2.3.050 T5 Neighborhood (T5N 40/60 and T5N 50/70)

Written by Richard Falk

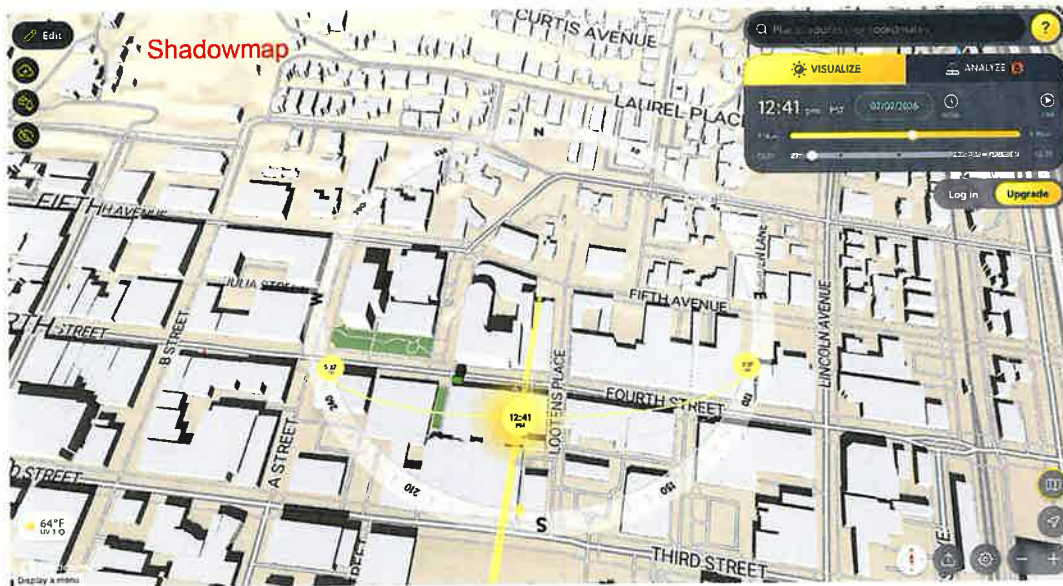
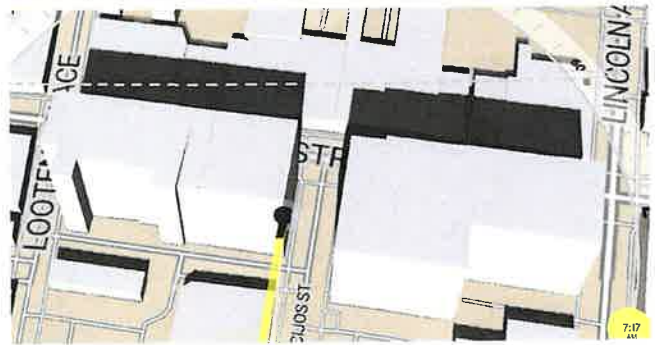
NOTE: This is during winter

60 feet height

120 feet height
